BOARD OF COUNTY COMMISSIONERS
ORANGE COUNTY, FLORIDA

ADDENDUM NO. 4 / IFB NO. Y16-764-PH

VISTANA WATER FACILITY SUPPLY IMPROVEMENTS

SCALE: NOTED
DRAWING NO.:
S06
SHEET: 24 OF 75

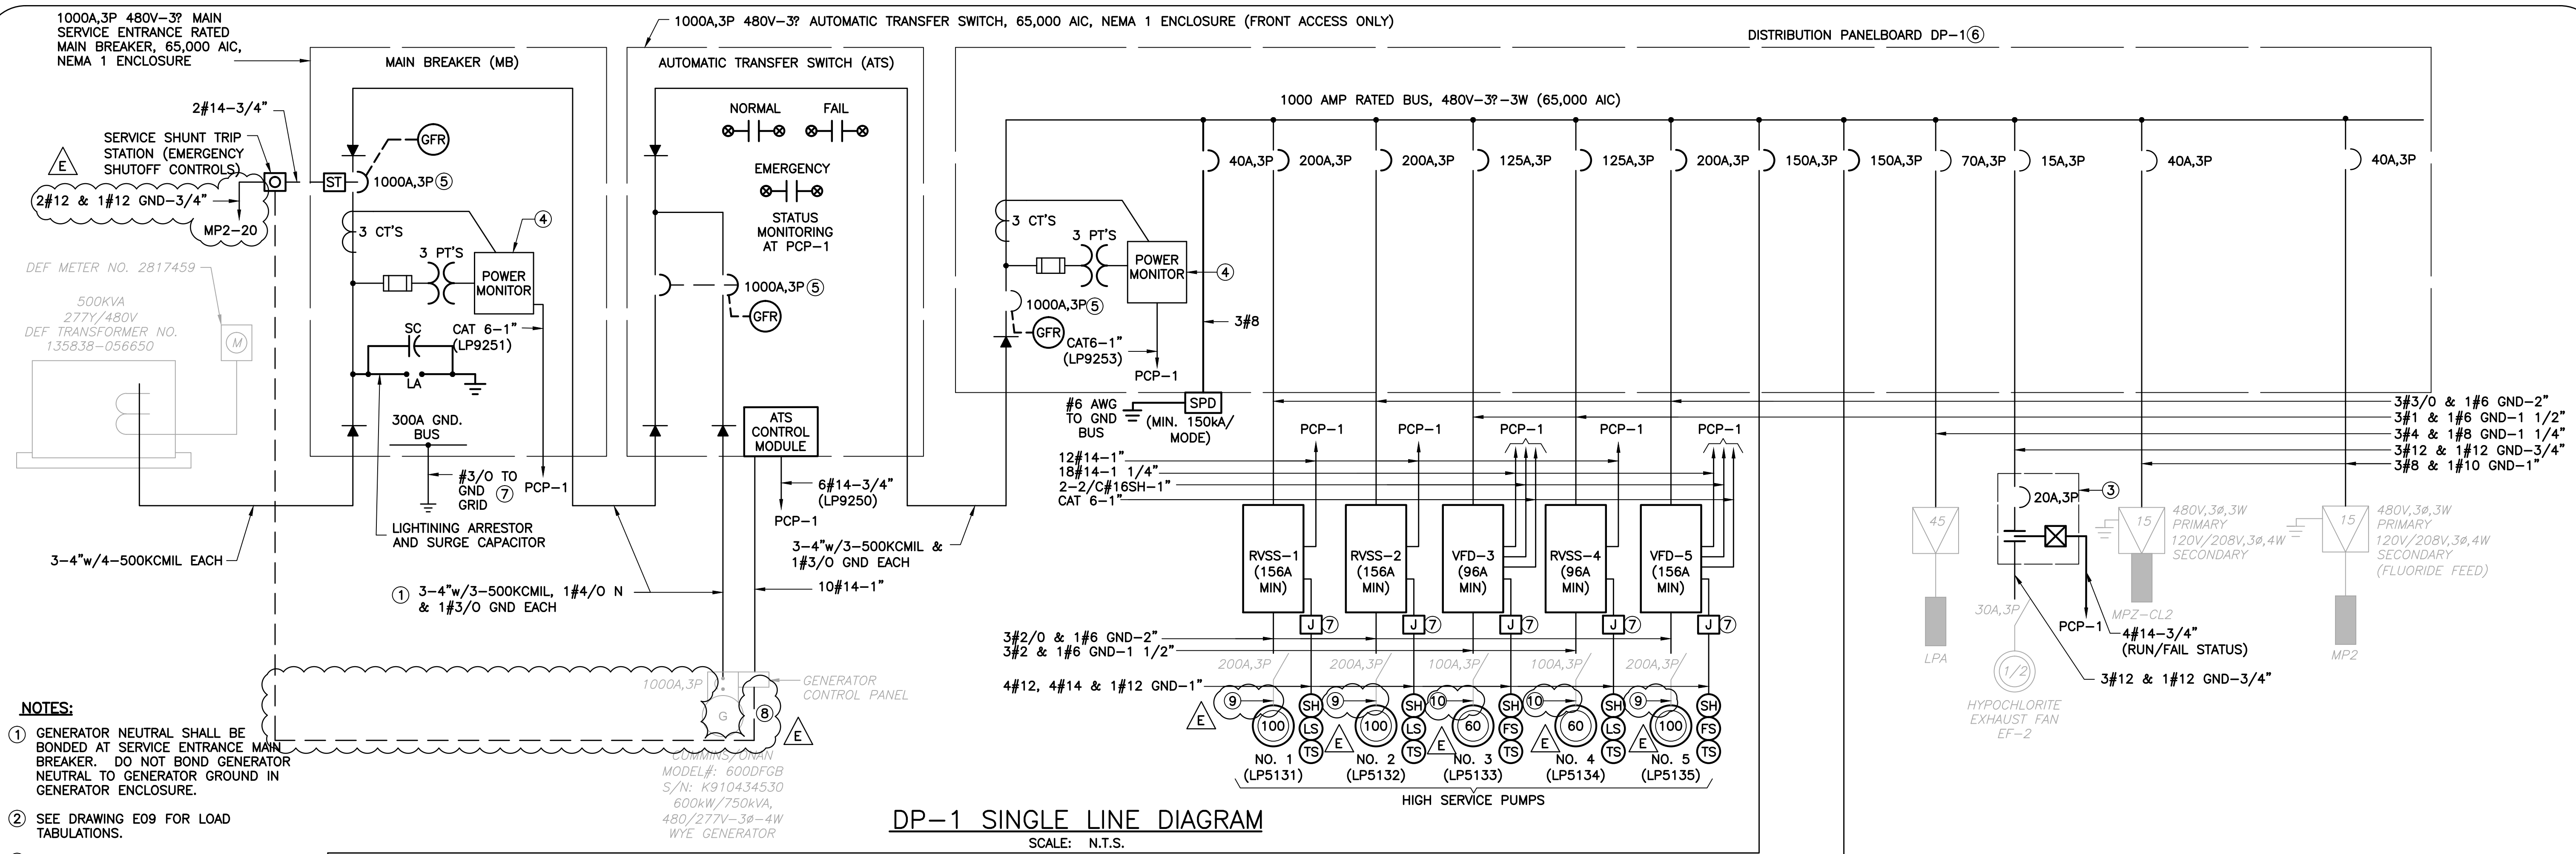
1. Drawing S06: Replace Drawing S06 in its entirety with the attached revised Drawing S06 issued as part of this addendum. The revised Drawing S06 adds Detail E for the existing window to be replaced and sealed with new concrete block wall shown on Drawing E10.
2. Drawing E03, Electrical Site Plan: delete pullbox detail reference “1” and replace with pullbox detail reference “3”.
3. Drawing E05: Replace Drawing E05 in its entirety with the attached revised Drawing E05 issued as part of this addendum.
4. Drawing E06: Replace Drawing E06 in its entirety with the attached revised Drawing E06 issued as part of this addendum.
5. Drawing E13: Replace Drawing E13 in its entirety with the attached revised Drawing E13 issued as part of this addendum.

OCU FILE NO.: 68767	SCALE: NOTED
DESIGNED BY: DD	DRAWING NO.:
DRAWN BY: RRM	E05
CHECKED BY: LMR	SHEET: 42 OF 75
CADD FILE: E05.DWG

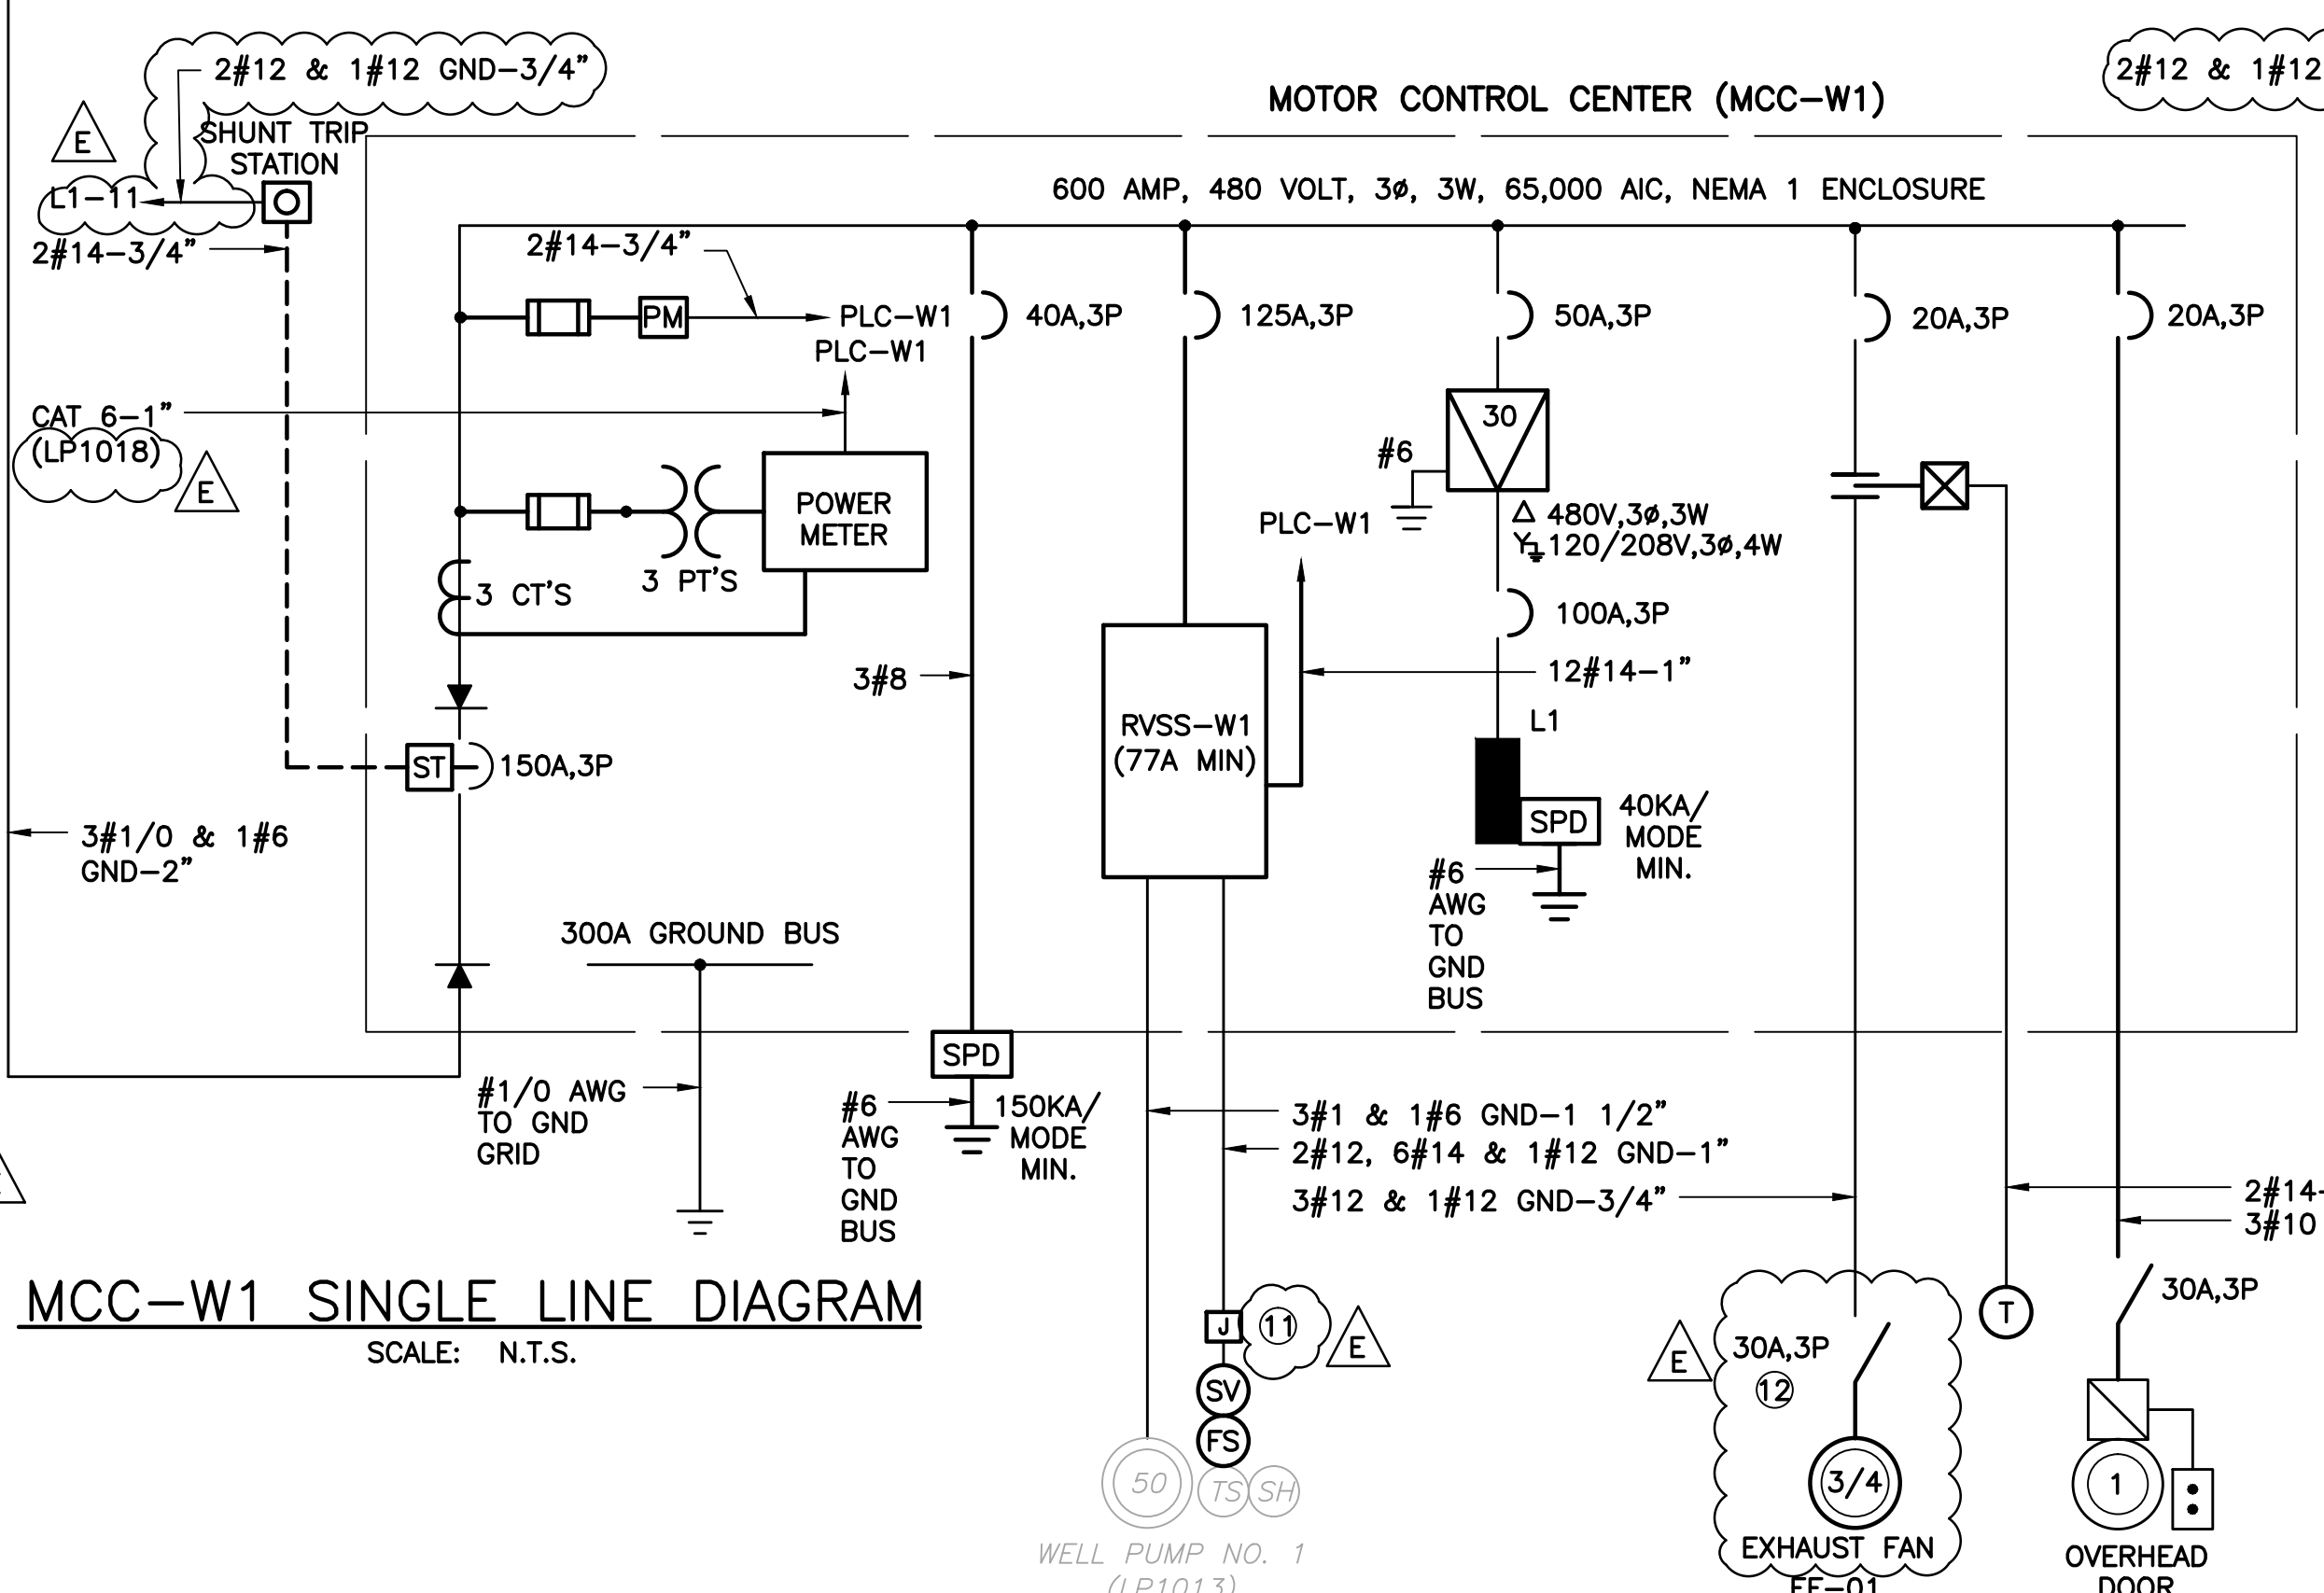
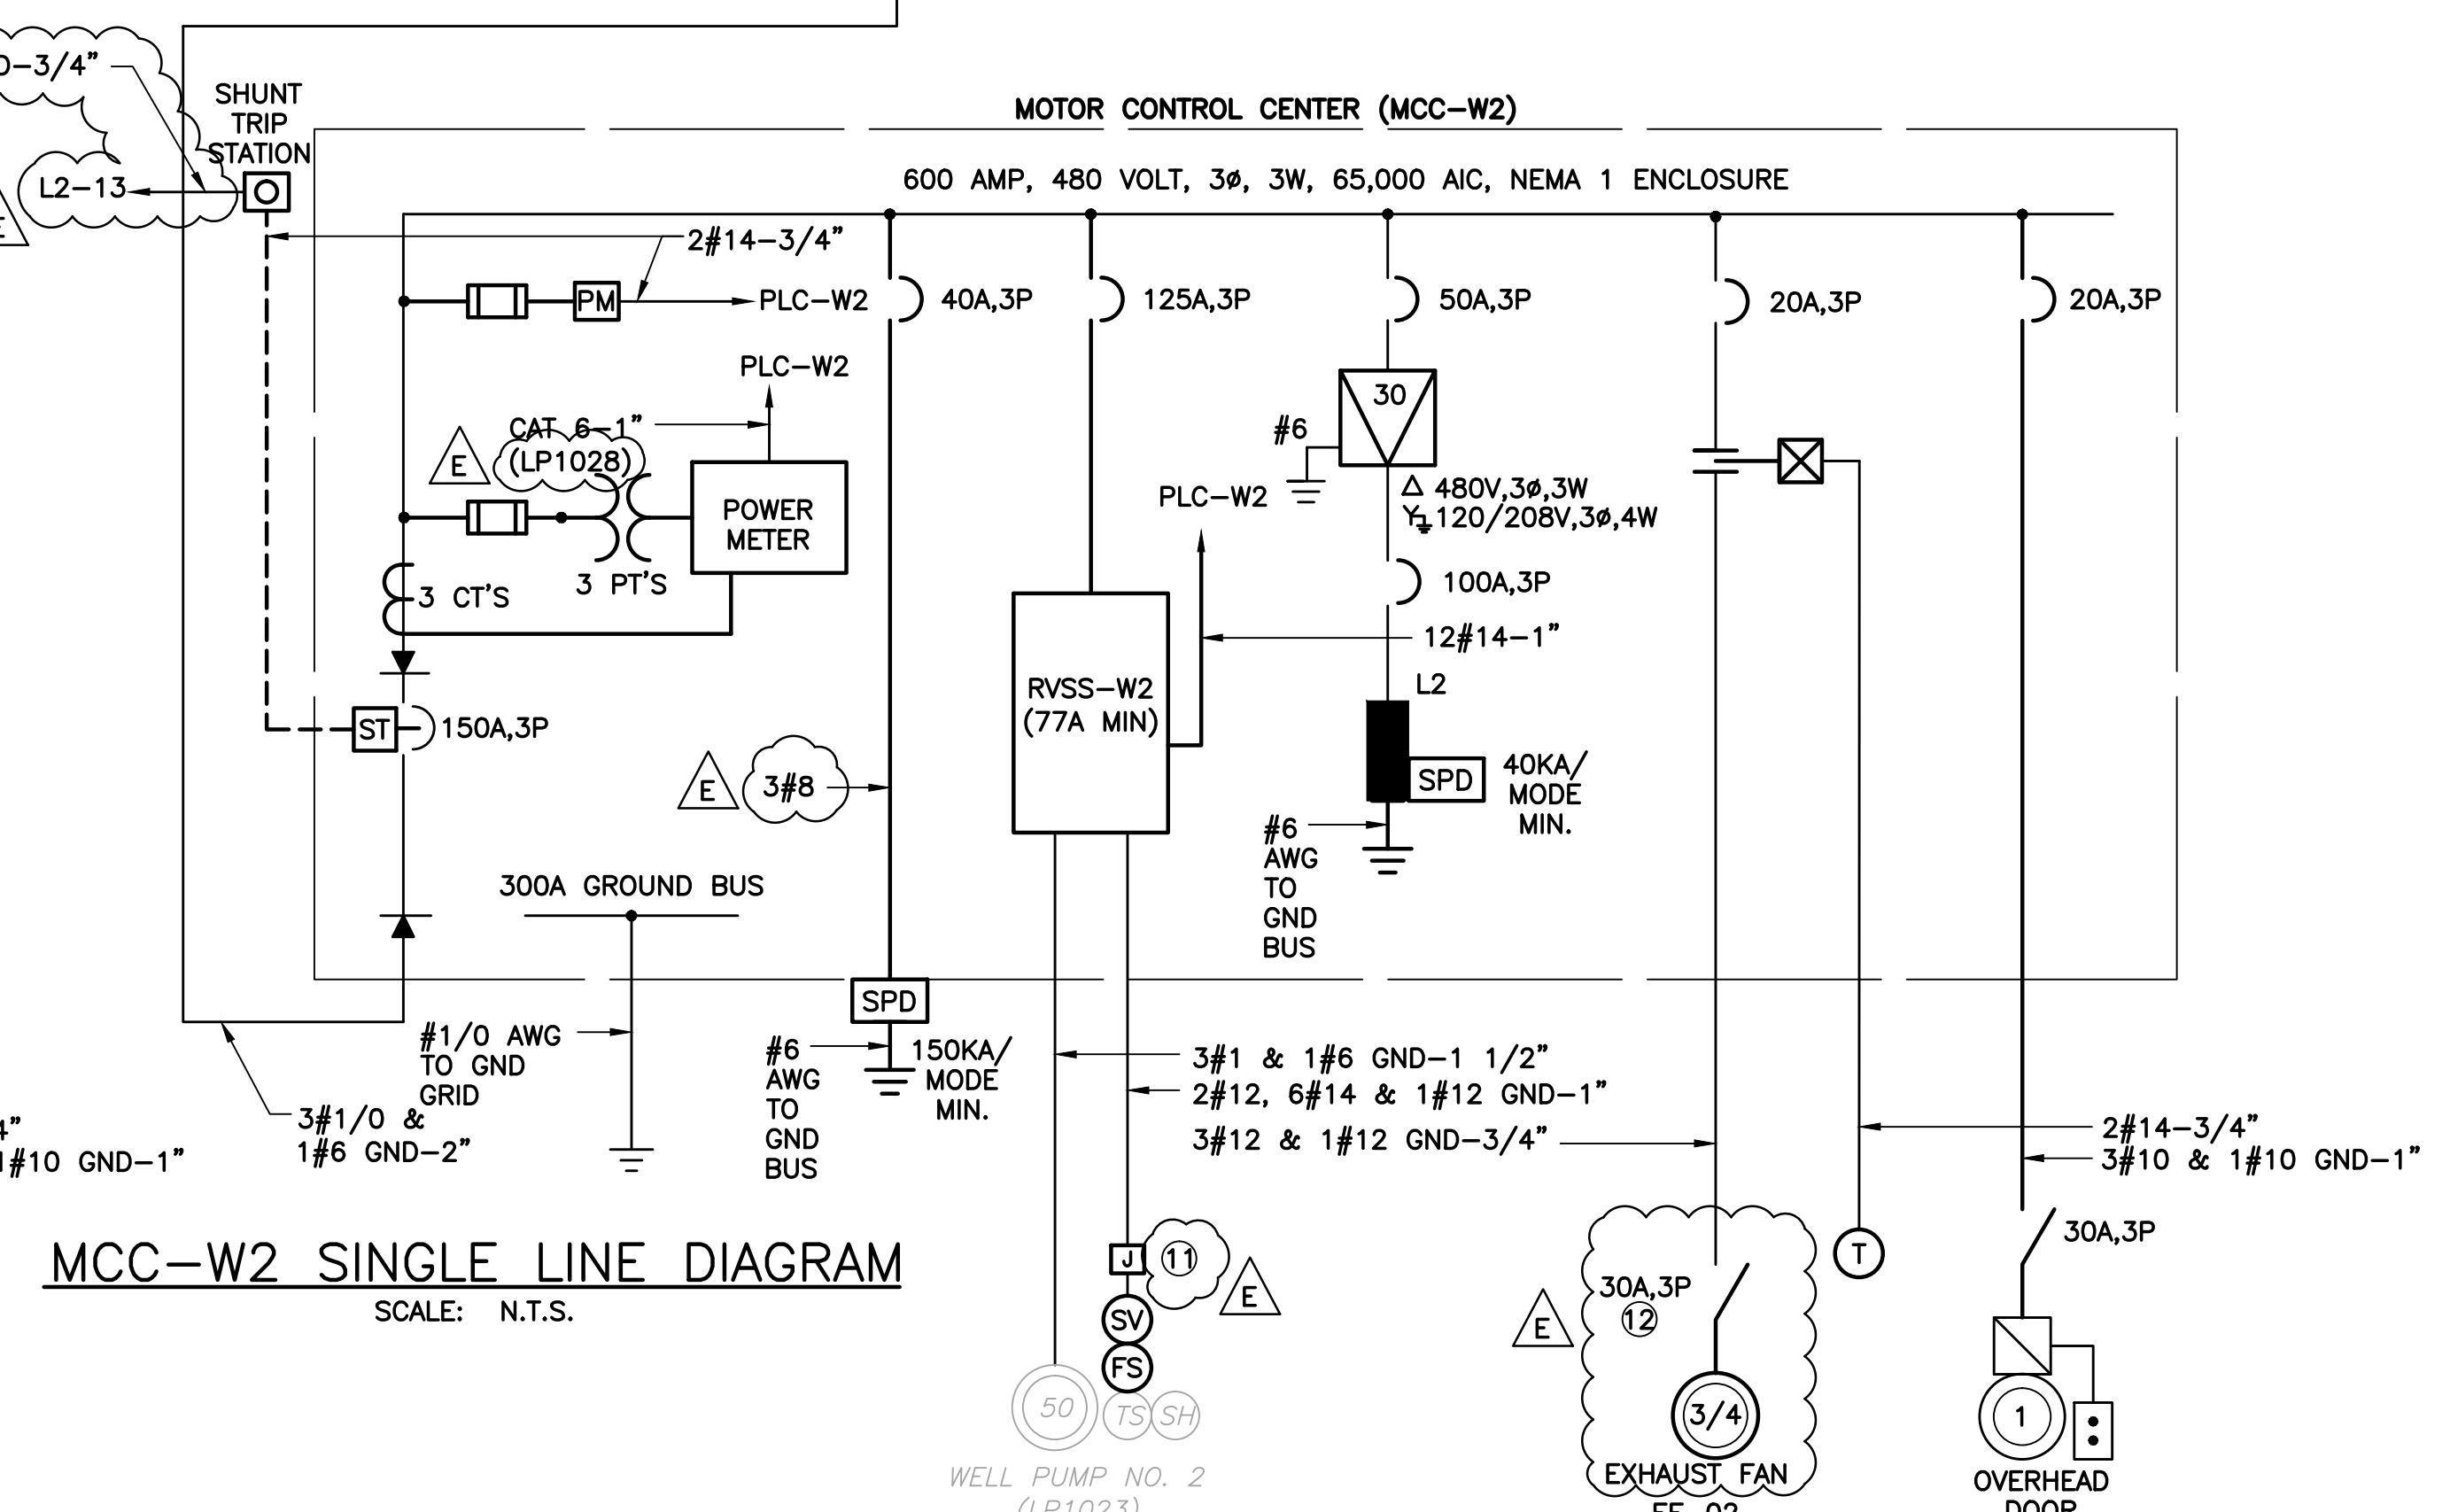
1. **The Existing generator at the Vistana WSF by design, is requested to be modified to provide shunt trip function. This generator was built in 1991. It is possible that generator set breaker is obsolete or not able to be modified or more over to be replaced in order to meet with design. Various phone call to Cummings service department in Florida and Georgia has been made and they are not able to provide the information requested. Please advise size, type, model and specifications of breaker.**

2. **In the tech specs on pdf pg. 6 under Description No. 4 states you are asking for “a new and sound attenuating enclosure for the existing emergency generator”. Can you tell me is your existing generator CAT (Caterpillar) or Cummins?**

Response: Coordinate with generator manufacturer to wire normally closed contact of the shunt trip station in series with the existing generator E-stop in the existing generator control panel. Or, if not available, wire normally closed contact of the shunt trip station in series with the existing generator start command. Refer to attached revised Drawing E05 issued as part of this addendum.

Model No. VTA28G2, Serial No. 25179801 and Generator Model No. 600DFGB, Serial #K910434530. The existing generator electrical specifications can be found on Drawing E05.
